Section 16 Planning Application for Proposed Mixed-Use Development (Proposed Flat with Permitted Commercial Uses) with Minor Relaxation of Building Height Restriction at Lot 4354 in D.D. 124, Kiu Tau Wai, Yuen Long (Application No. A/HSK/617)

Response to Departmental Comments

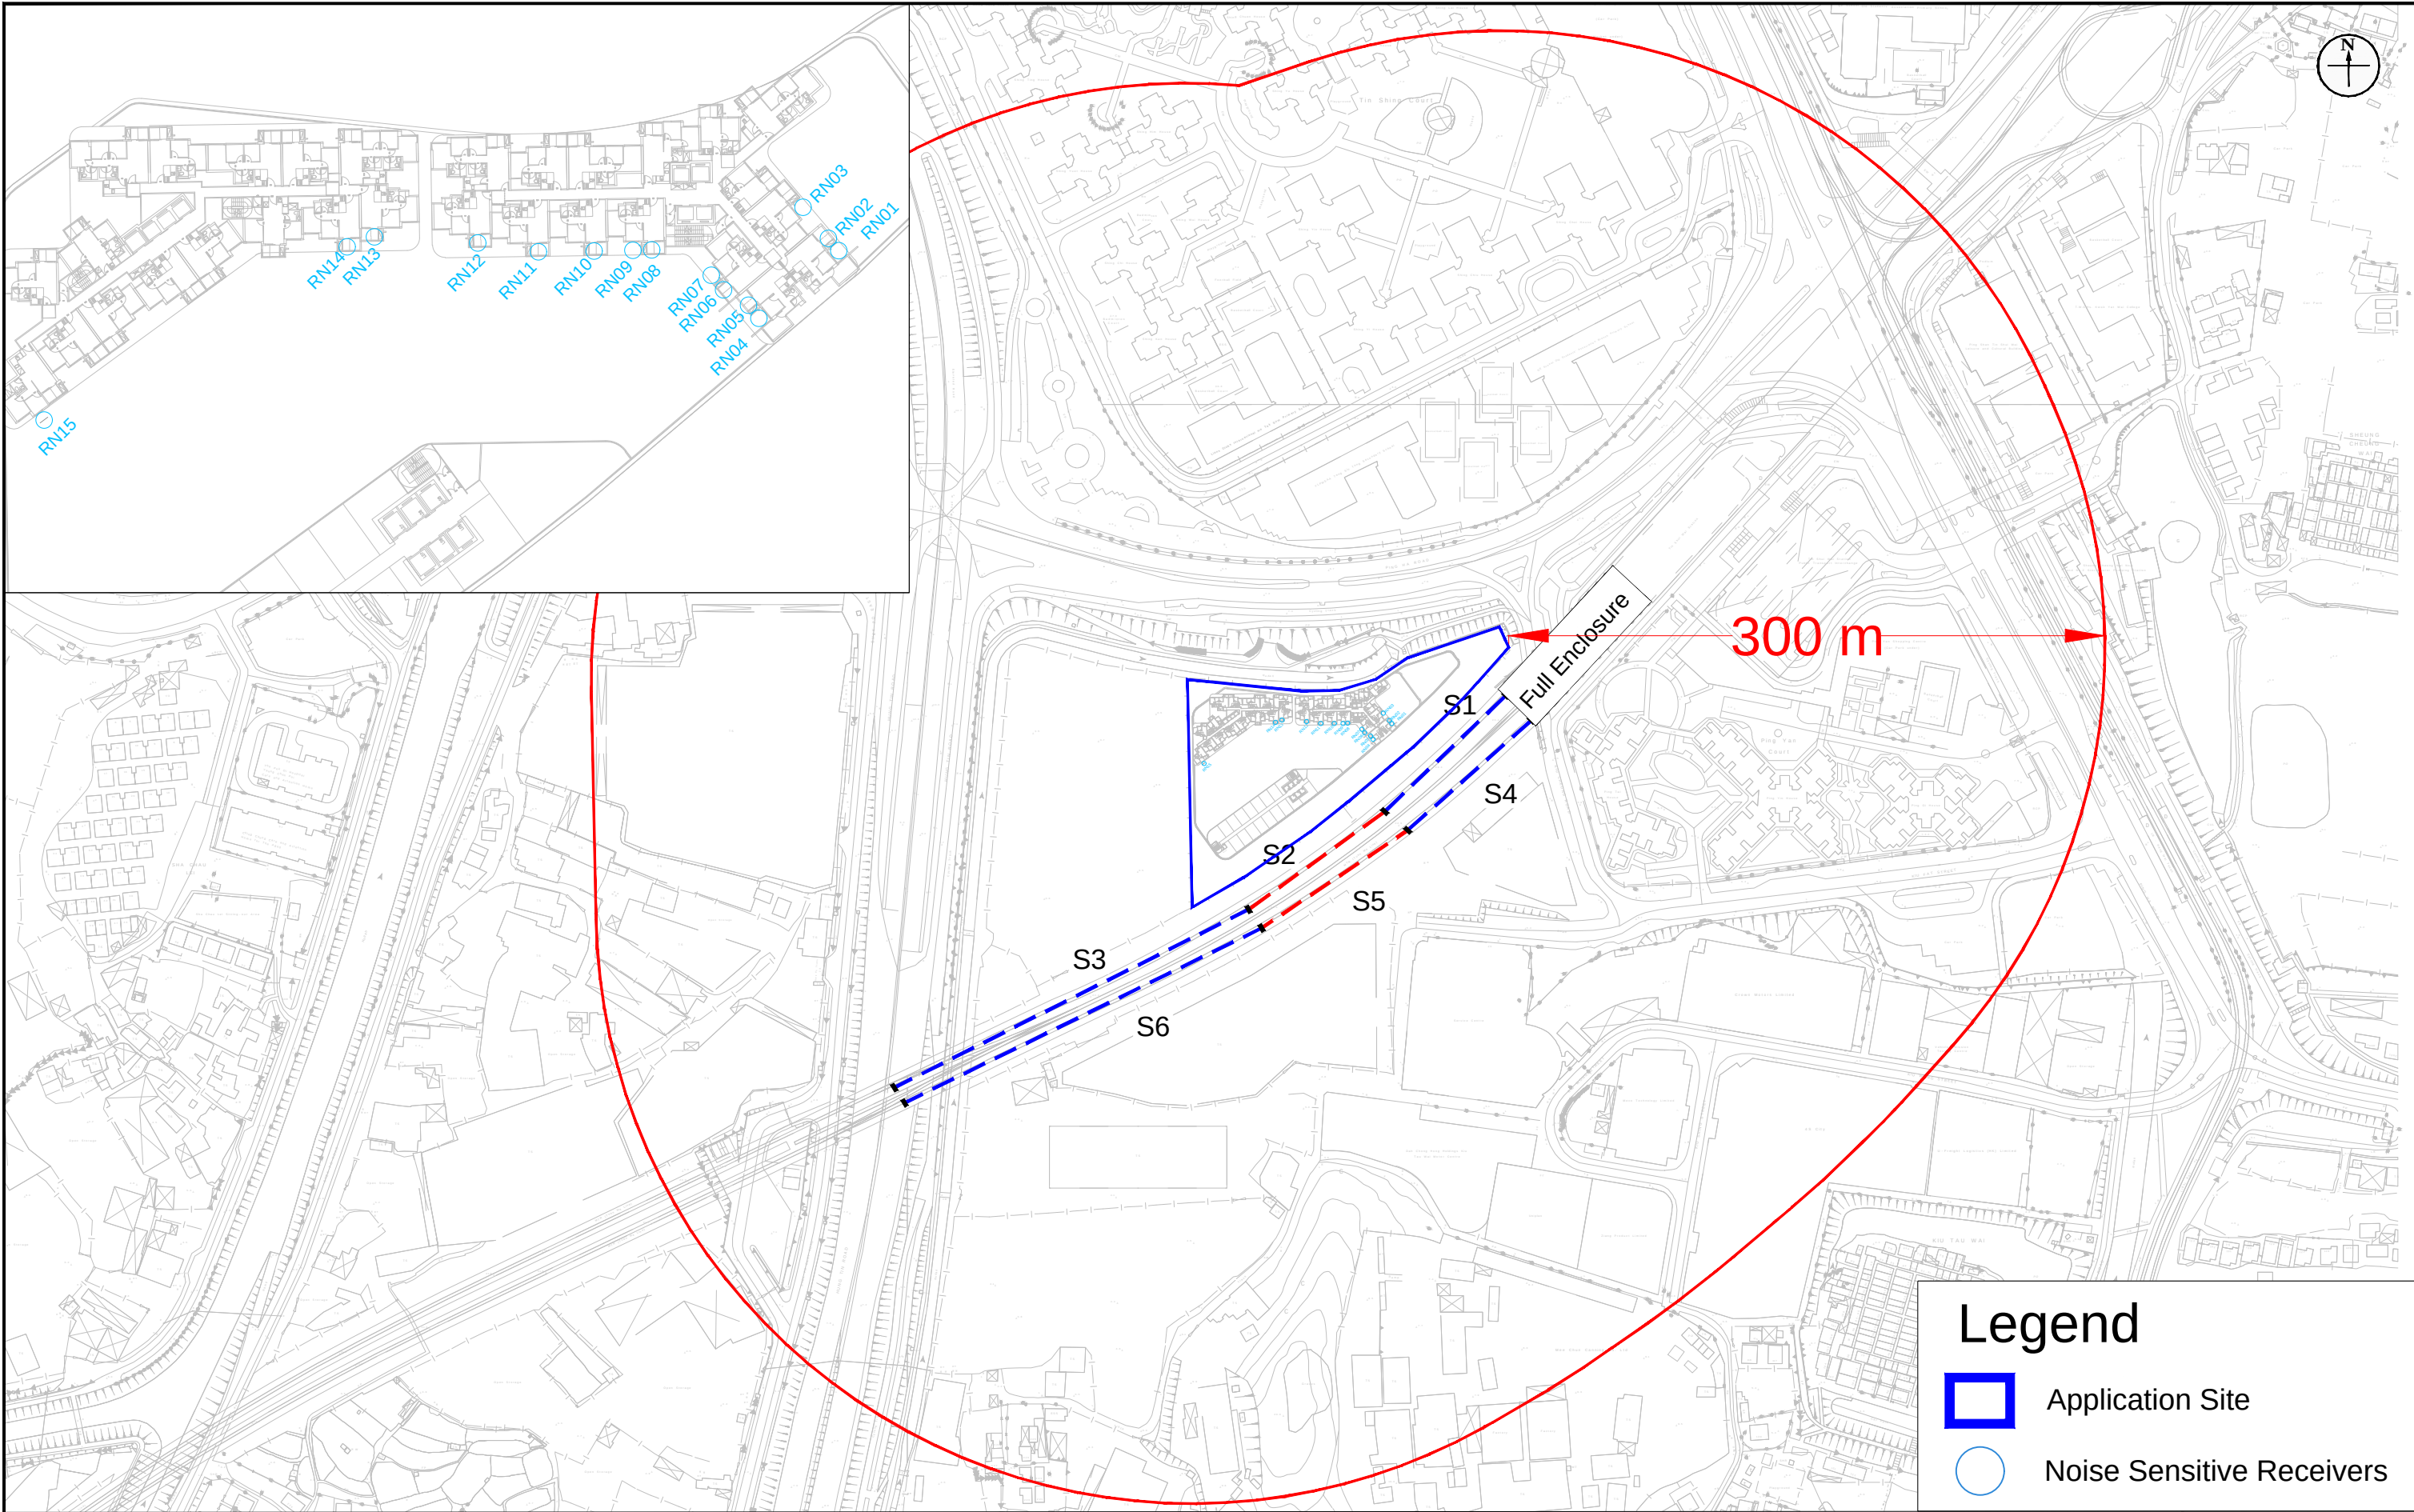
Departmental Comments	Responses to Comments
4.31	S3.4.10 – Please supplement a figure to demonstrate that all the railway track within the 300m radius of the proposed development is included in the assessment to ensure there is no underestimation on the railway impact assessment. Please review and revise as necessary.	Noted. Figure 3.1 of the EA replacement pages under Attachment 4 has been revised accordingly.

Figure: 5.1
Title: 500m Assessment Area from the Site Boundary of Development Site for Water Quality Impact Assessment and Water Sensitive Receiver
Project: Section 16 Planning Application for Proposed Comprehensive Development at Lot No 4354 in D.D. 124, Kiu Tau Wai, Ping Shan, Yuen Long

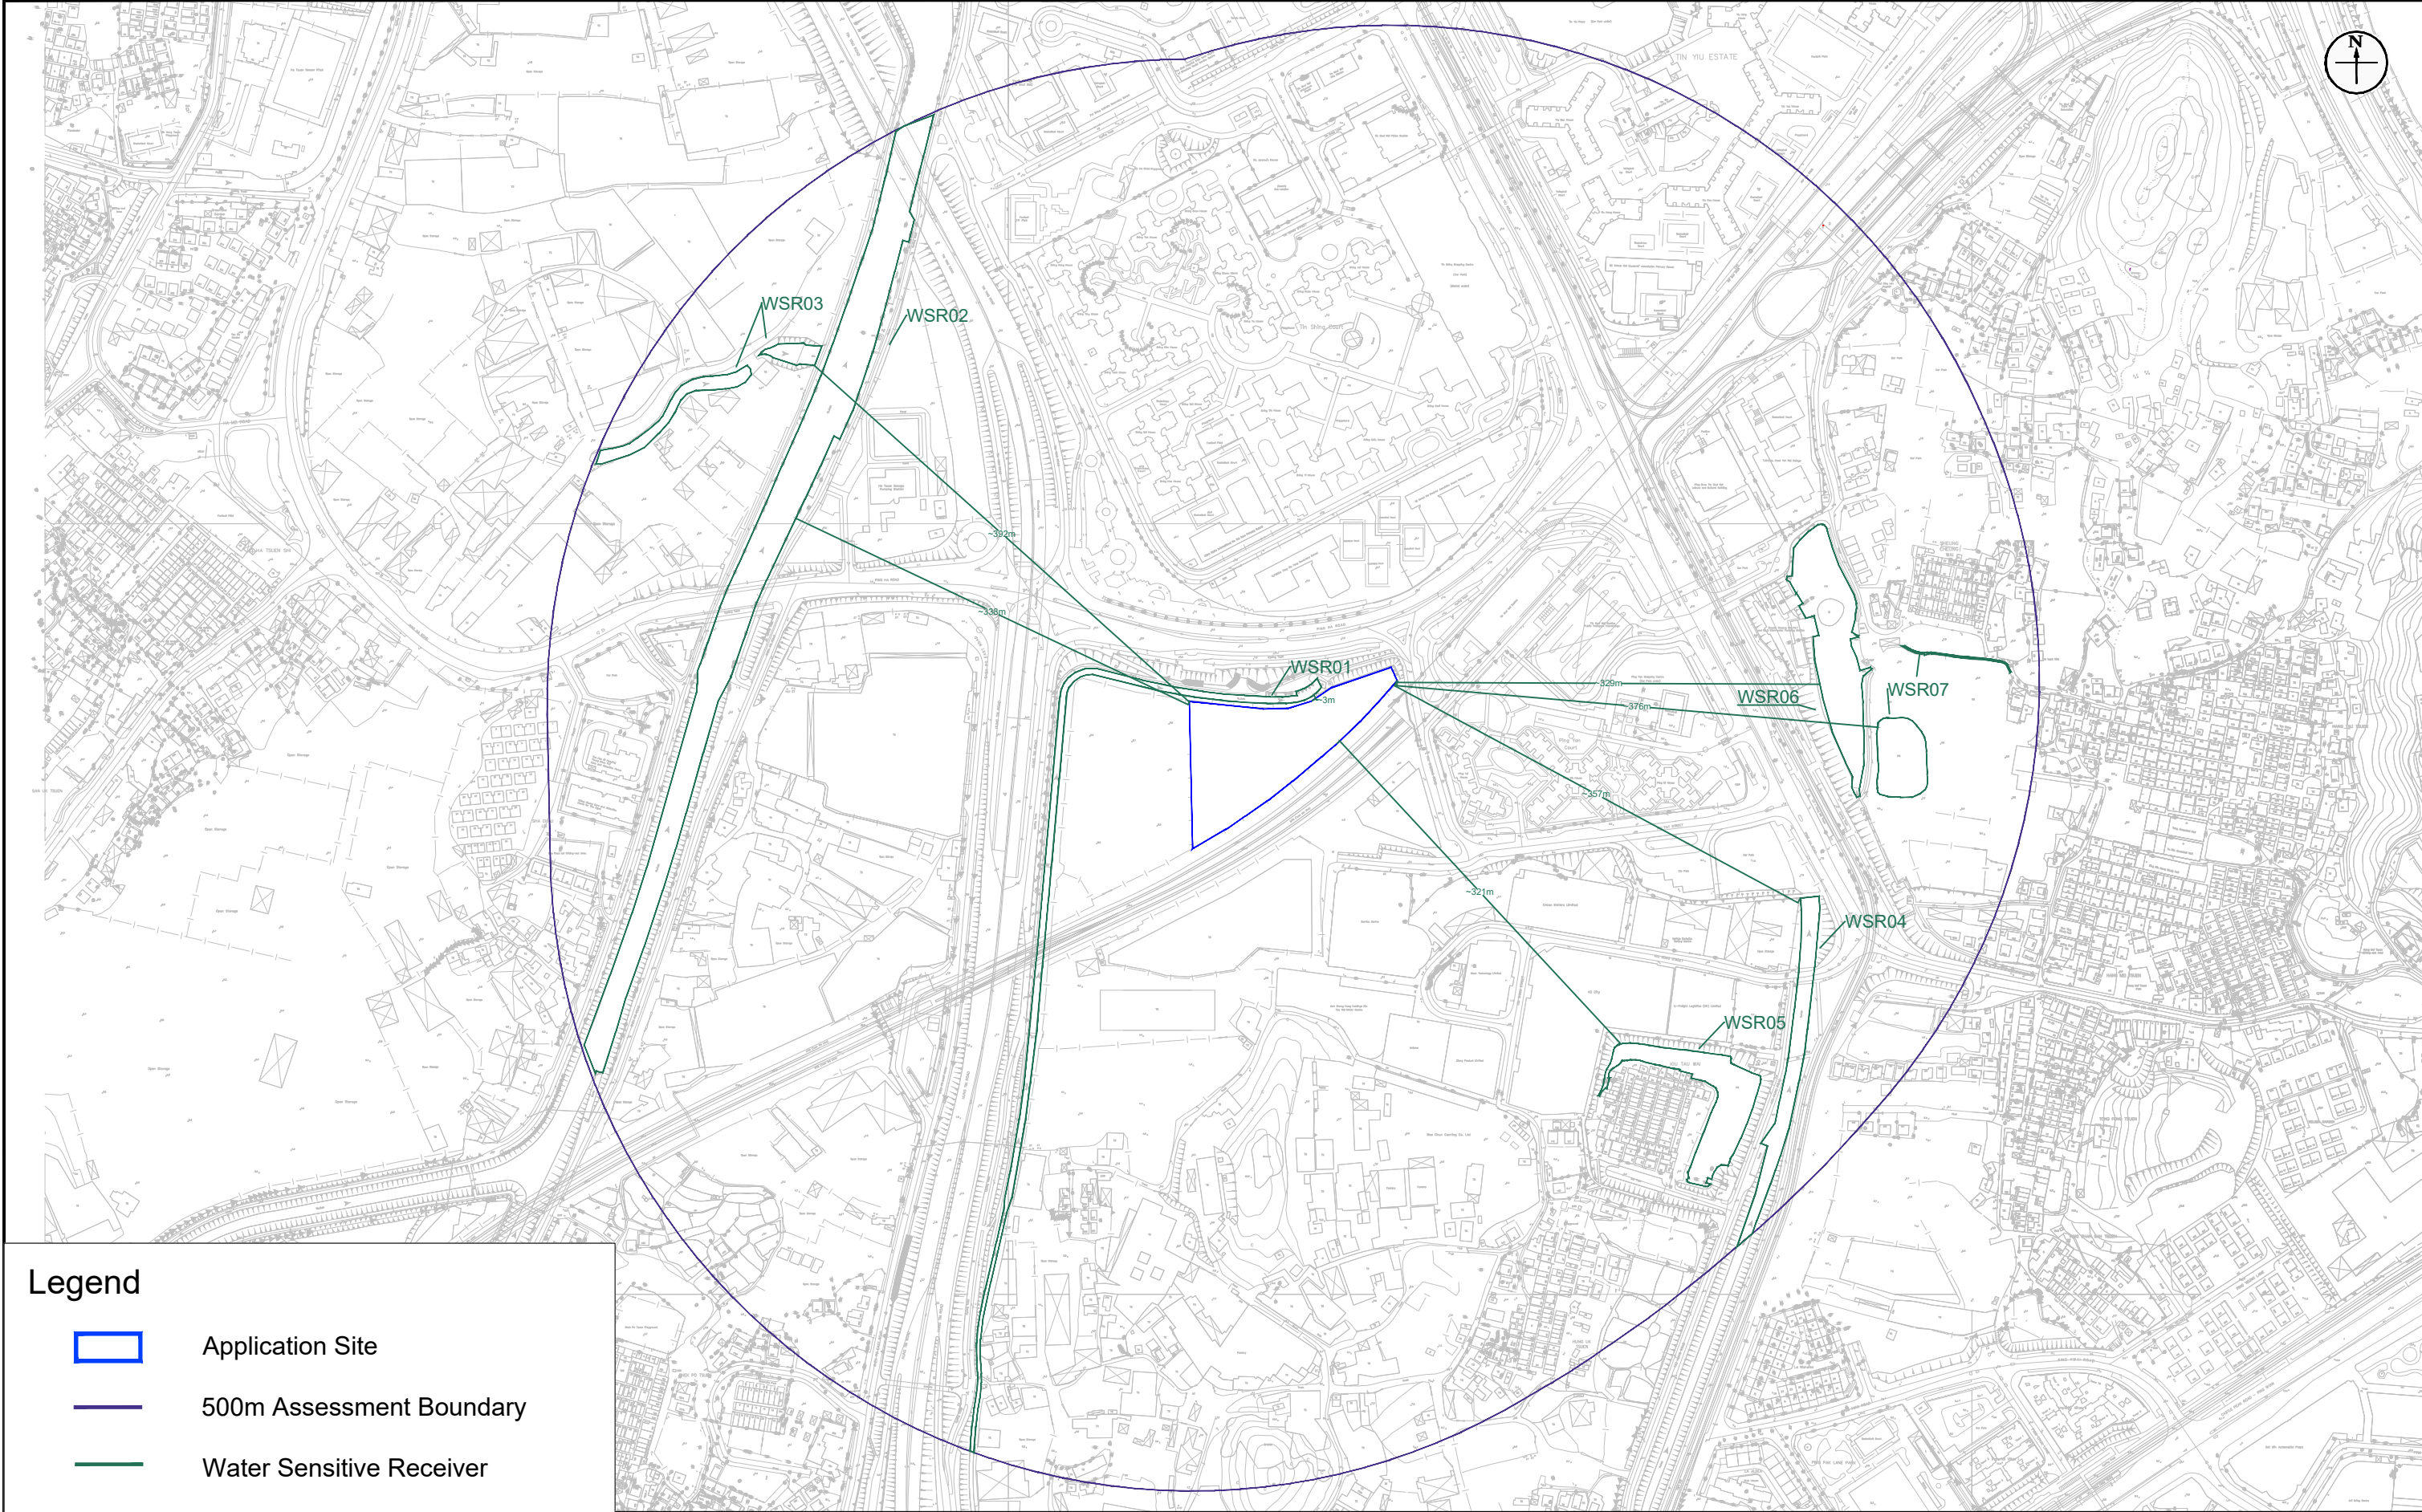
4.9	<u>Water quality</u> Table 5.1: Suggest to review if Tin Shui Wai Main Channel in the west and channel to the southeast are WSRs.	Noted. Figure 5.1 and Table 5.1 of the EA replacement pages under Attachment 4 have been supplemented accordingly.

4.21	Figure 5.1: Suggest to include the North arrow and scale.	Noted. Figure 5.1 of the EA replacement pages under Attachment 4 has been revised accordingly.

SHEET NUMBER
60640967/DIA/Figure 4

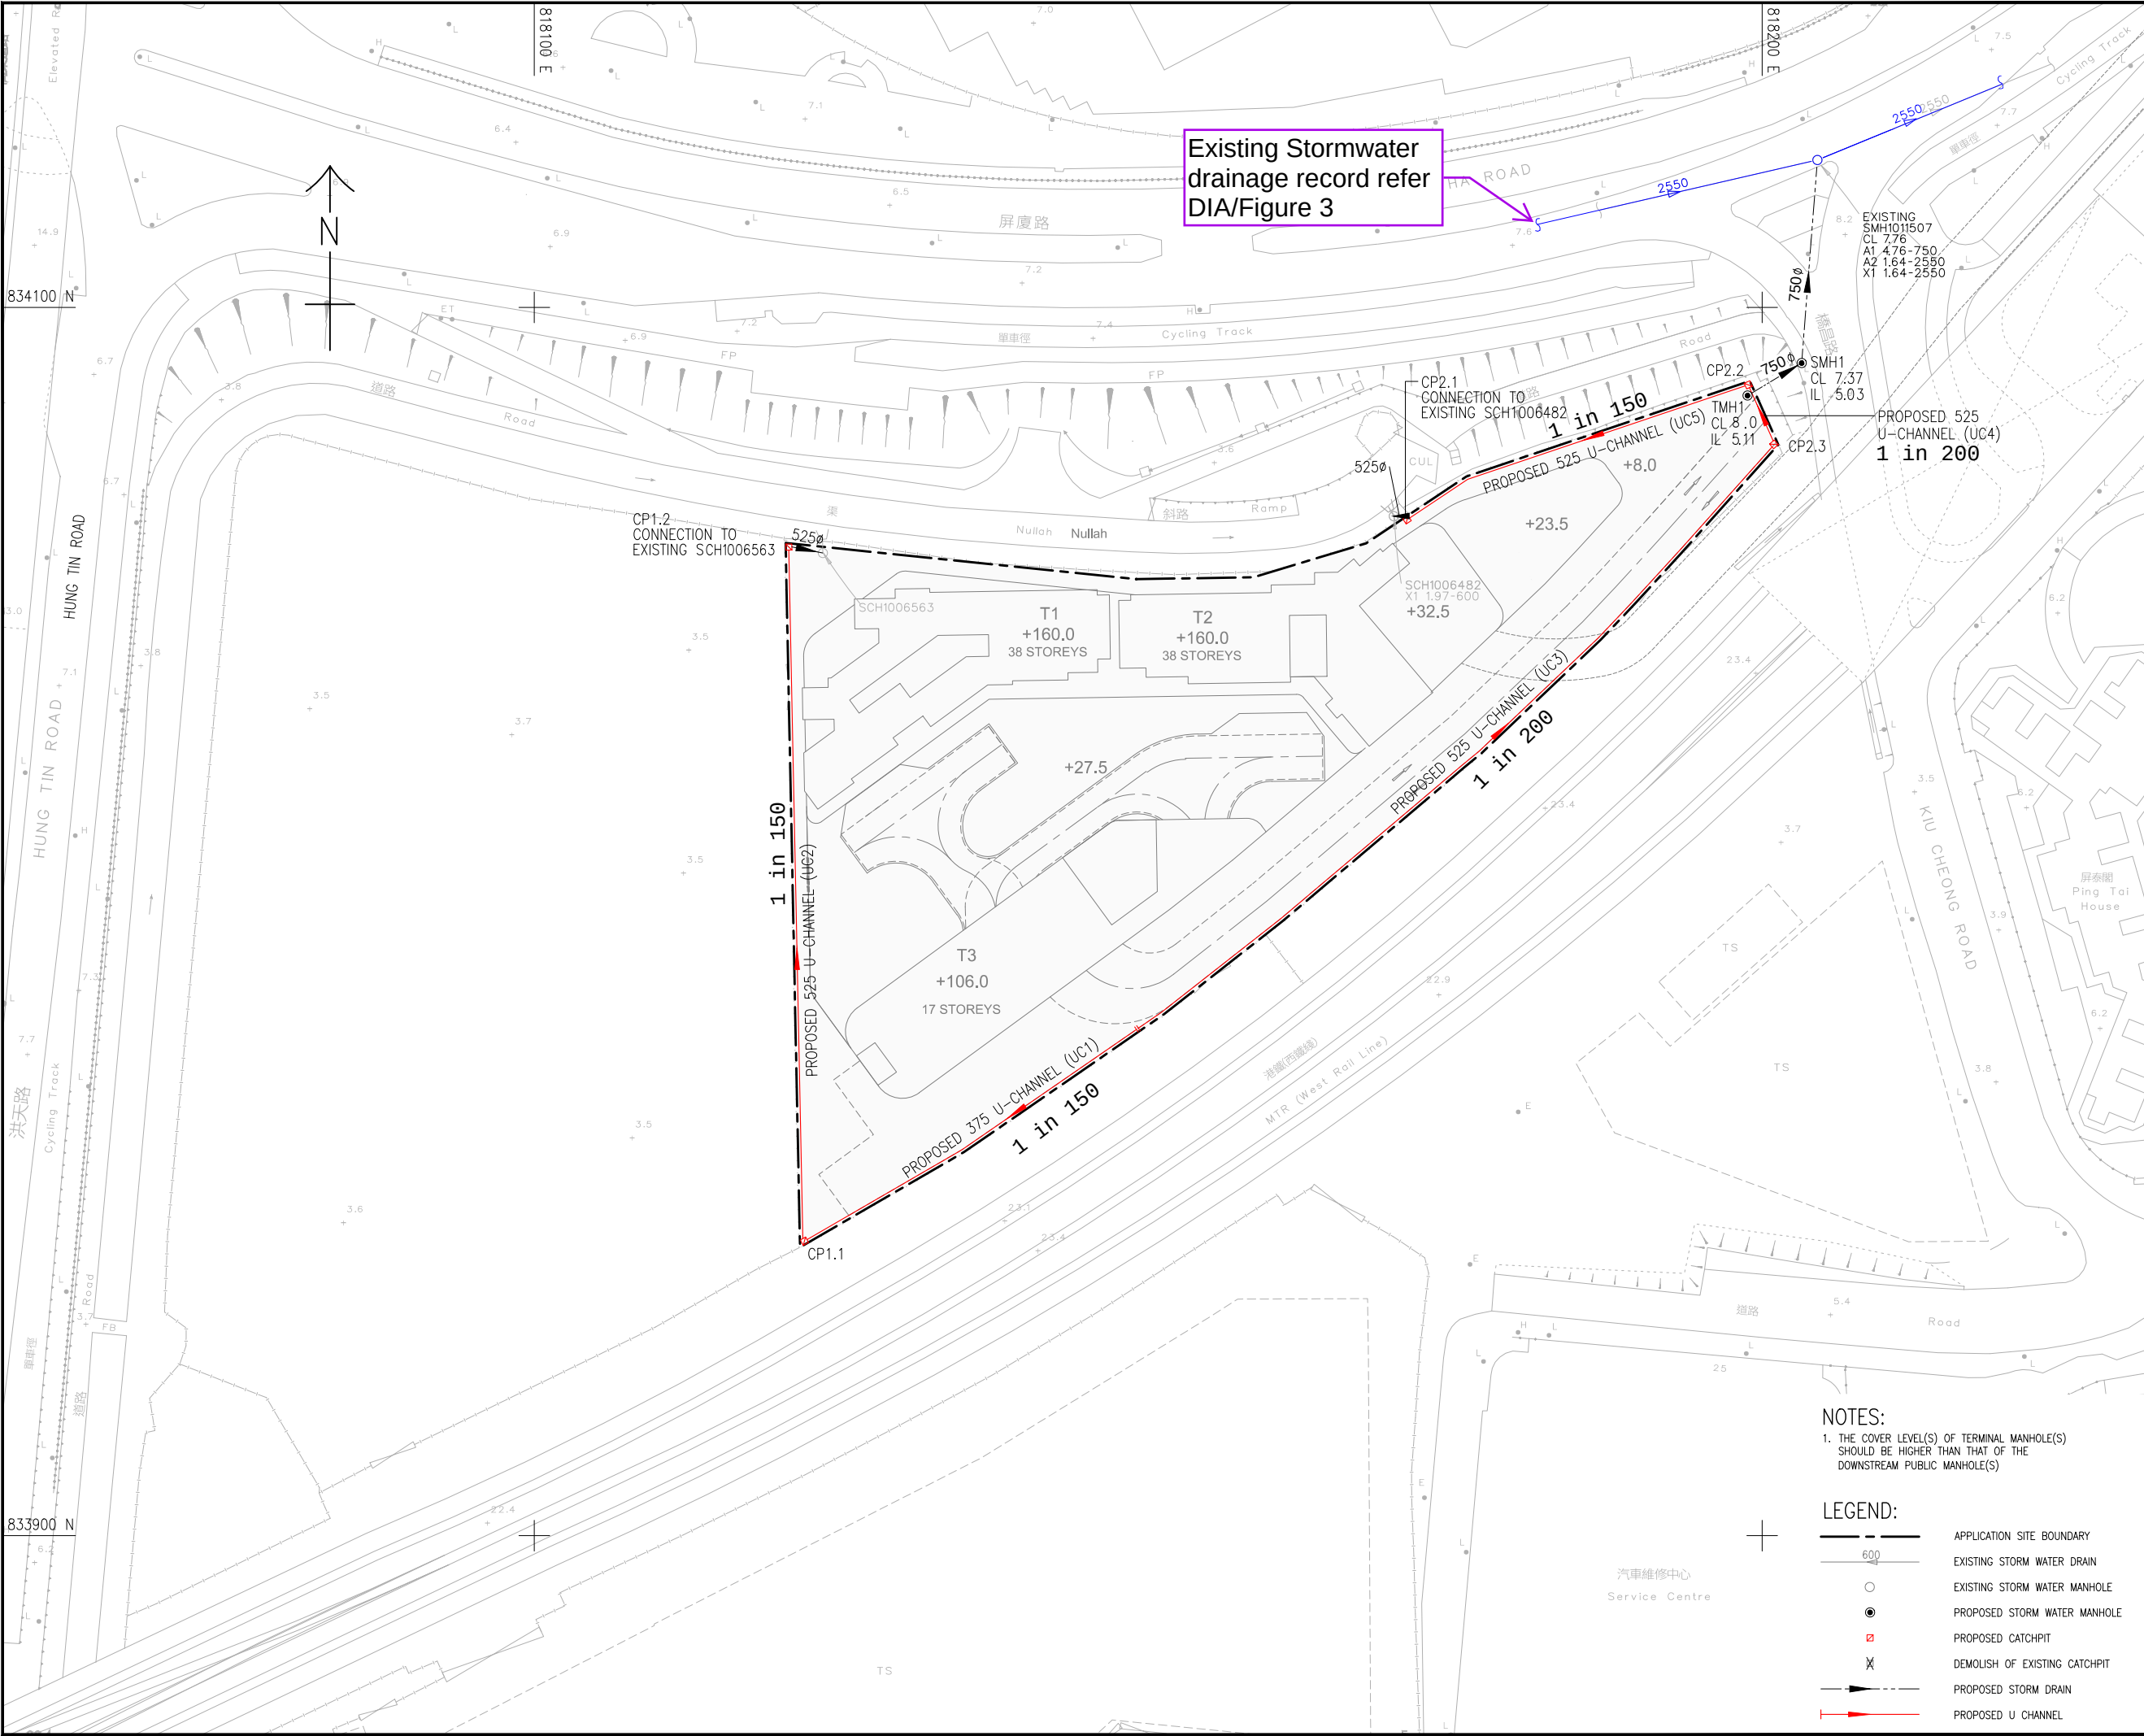
3.2	The gradient of the proposed drainage facilities shown be indicated on the drainage plan.	The gradients have been indicated on the updated Figure 4 of the DIA replacement pages under Attachment 5 .
